TRANSPORTATION CABINET

CALL NO. 101
CONTRACT ID NO. 141079
ADDENDUM # 2

Subject: Scott County, NHPP 0756 (100)
Letting December 12, 2014

- (1) Revised - Plan Sheets - R2g, T76, T77, & T78
- (2) Revised - CAP Note - Page 123 of 207
- (3) Revised - Bid Items - Pages 200-207 of 207
- (4) Added - Notes - Pages 1-6 of 6

BASE MOUNTED SERVICE DETAIL LCC2

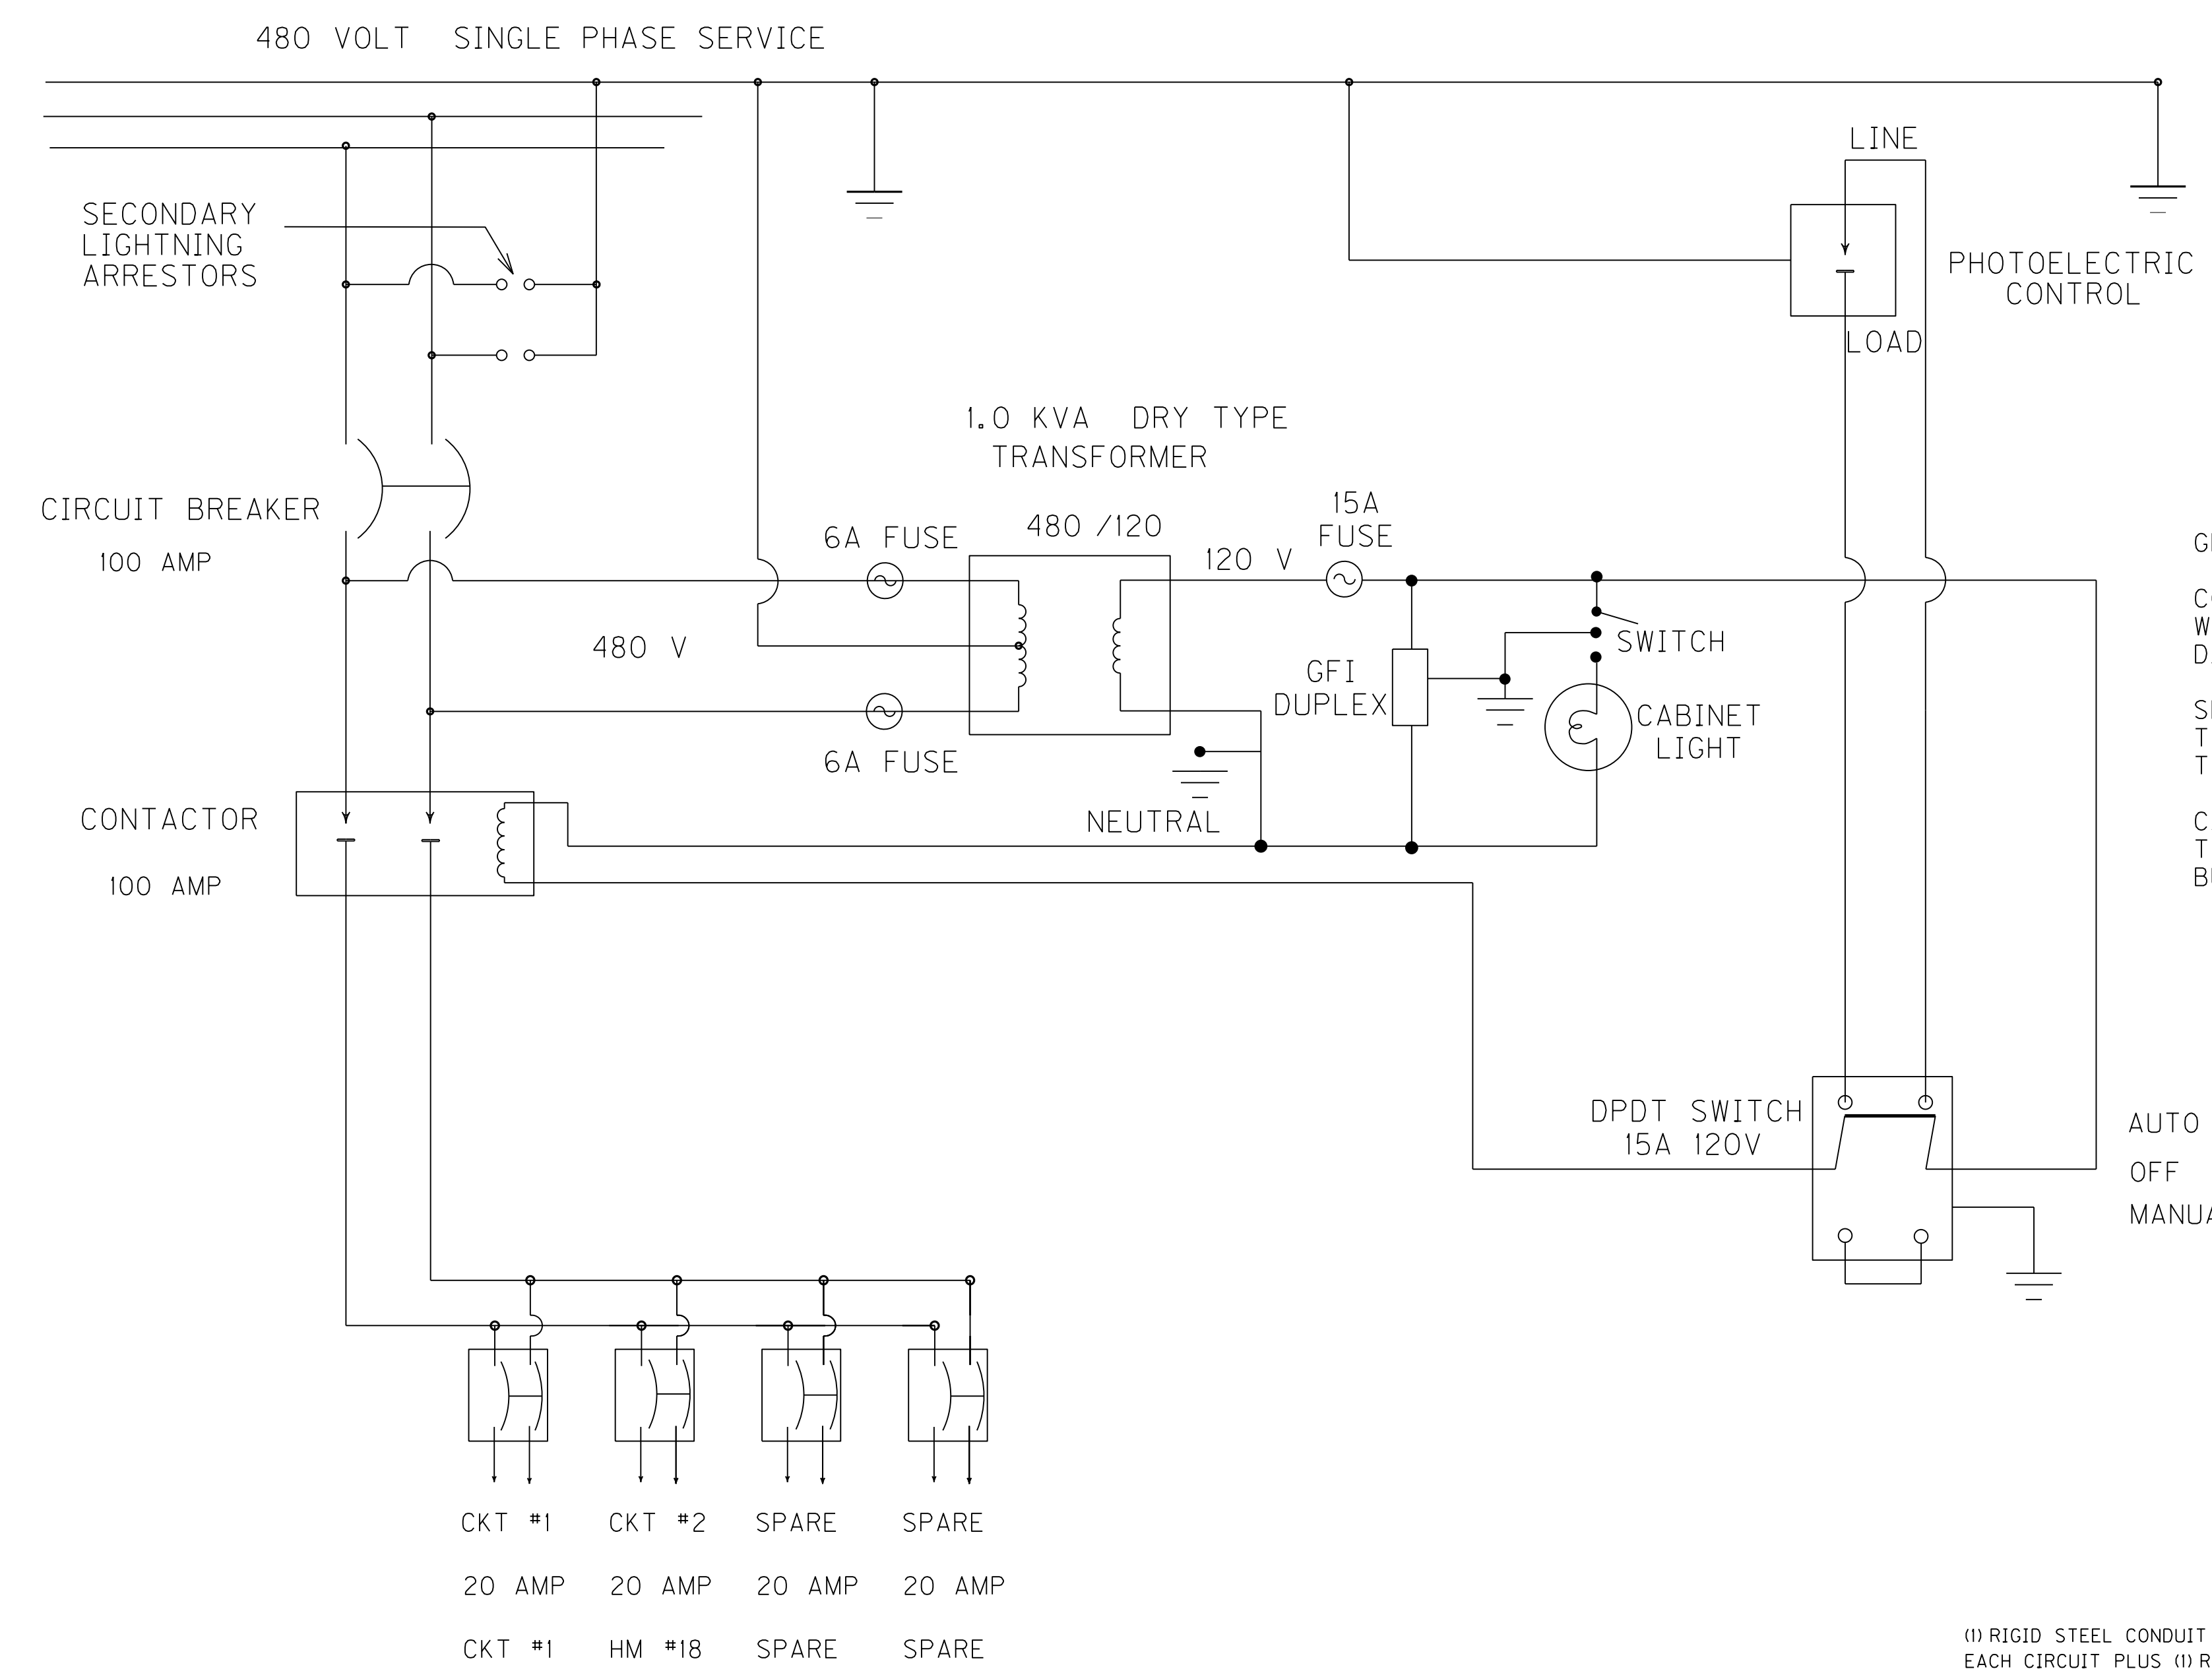
Relocated

Remove and relocate

Changed date

BASE MOUNTED SERVICE DETAIL LCC4

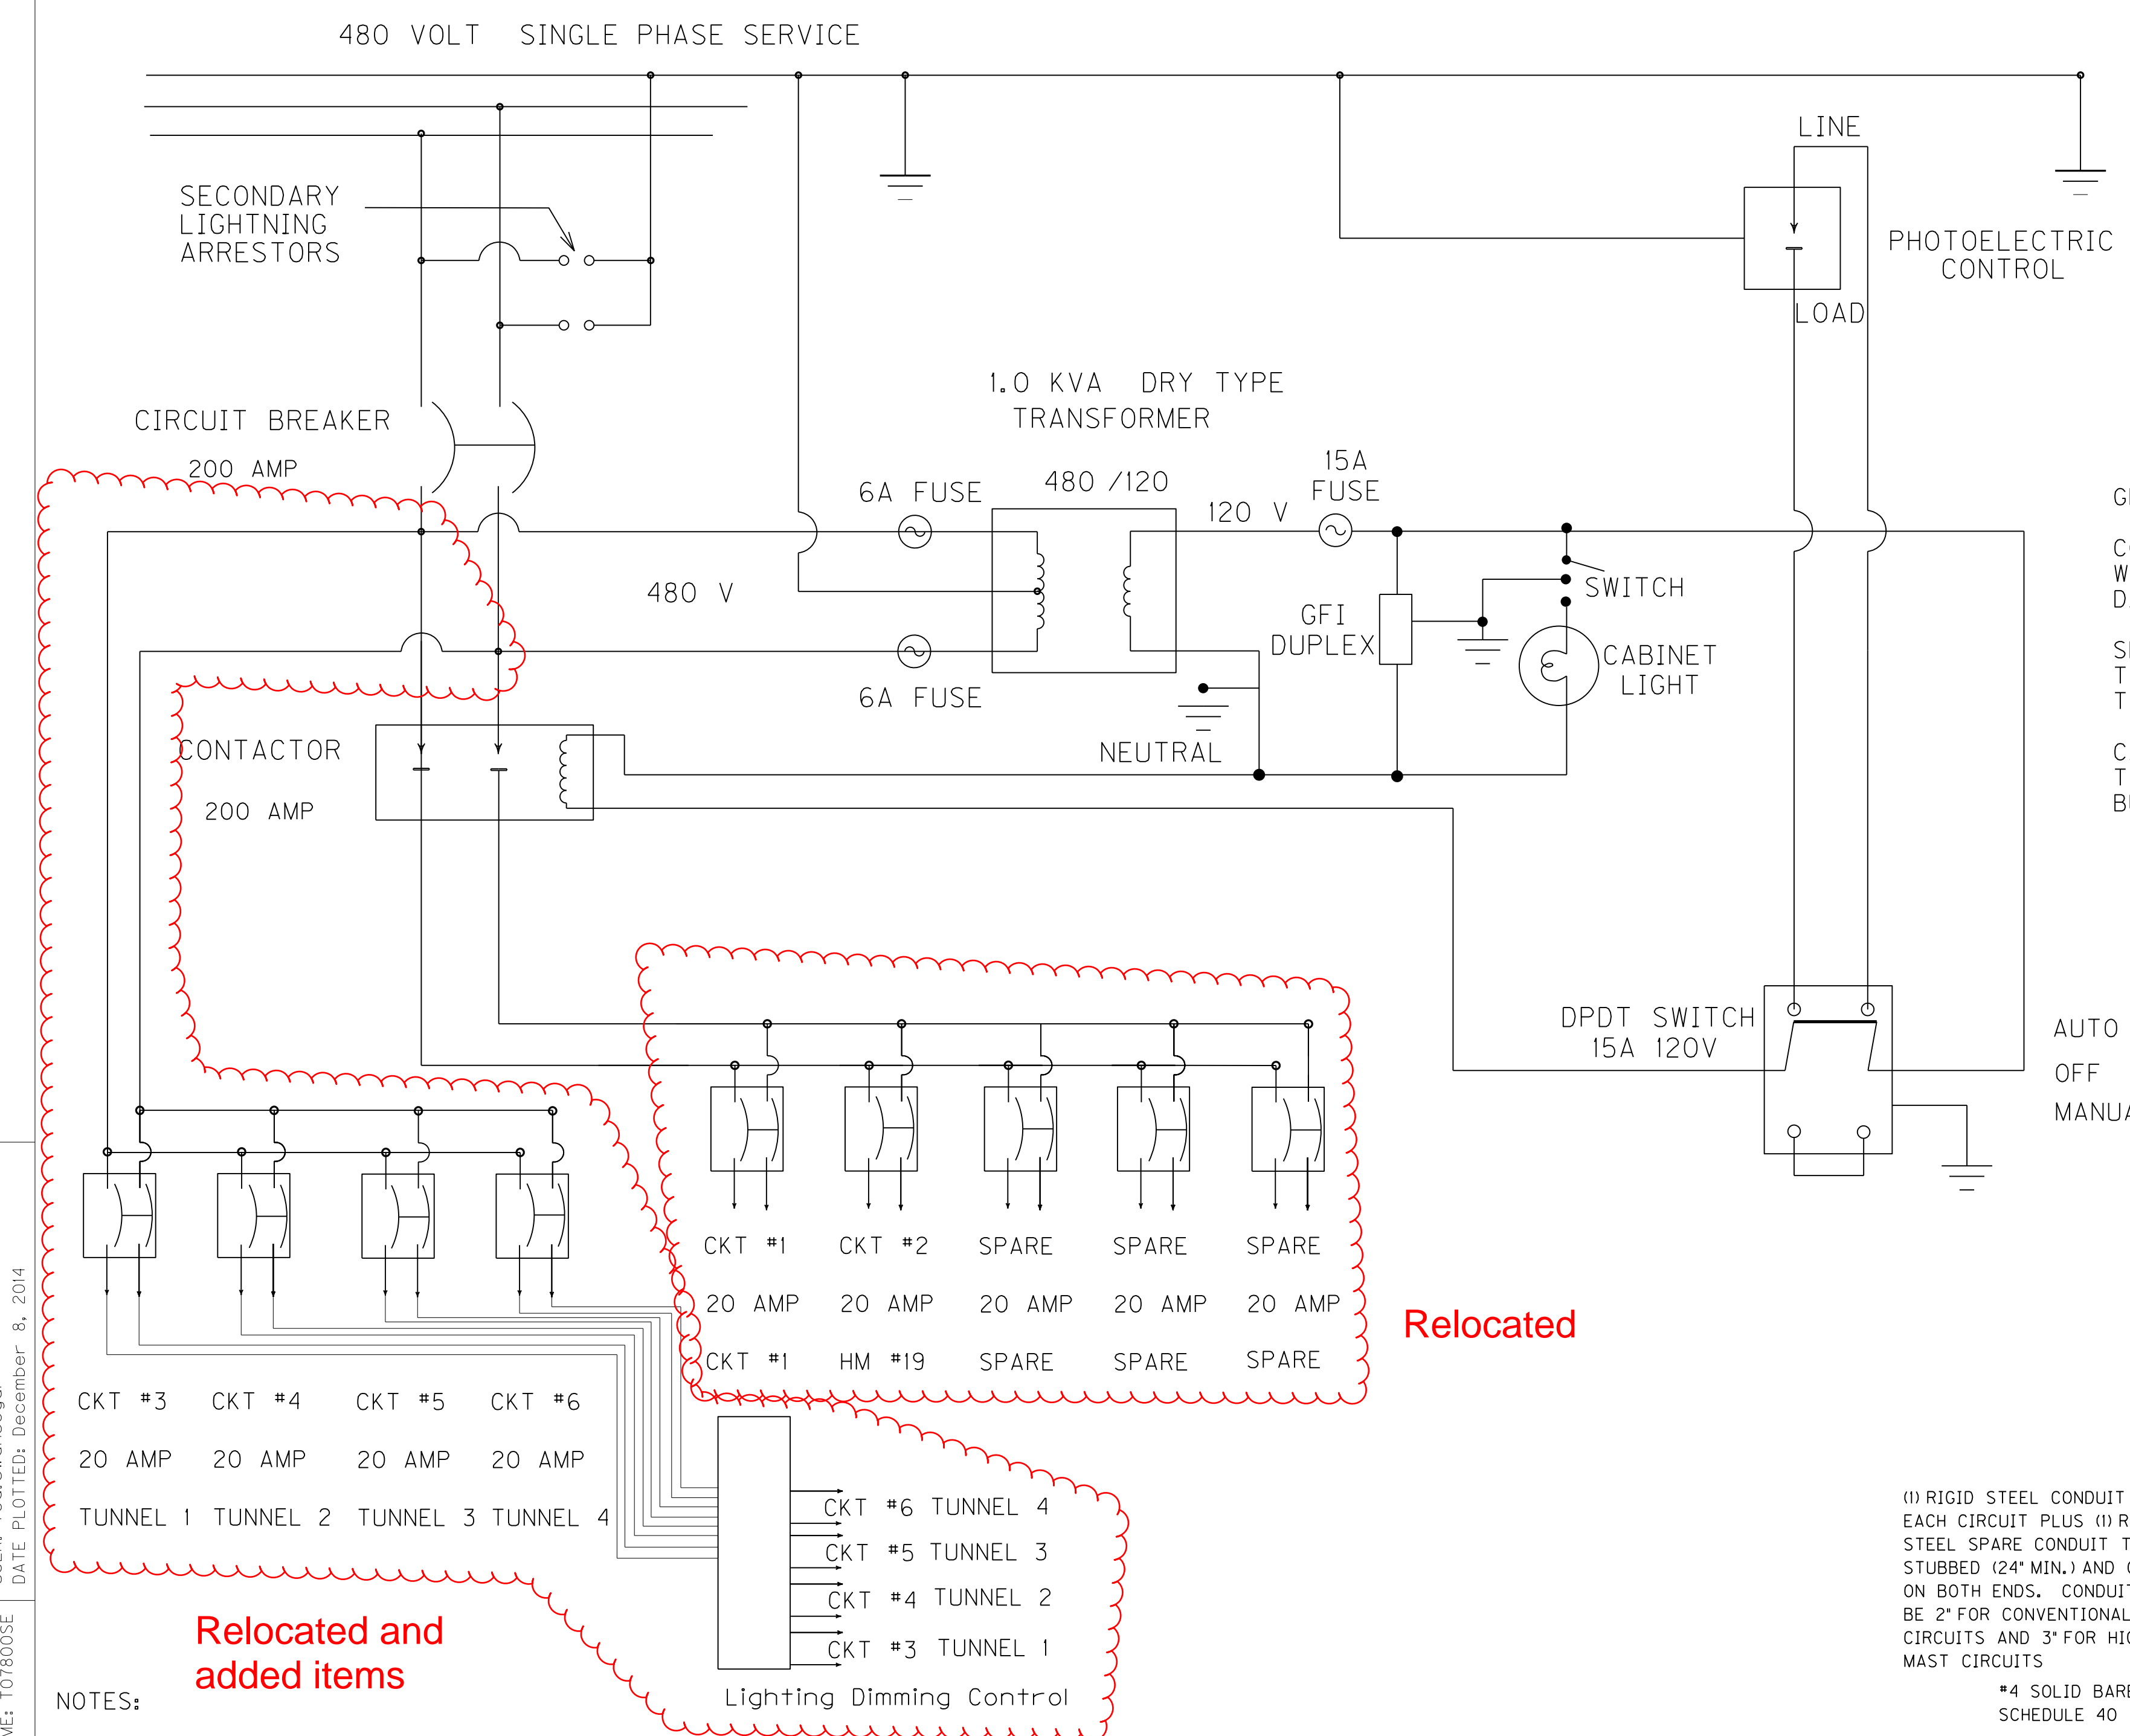
Relocated and added items

Relocated
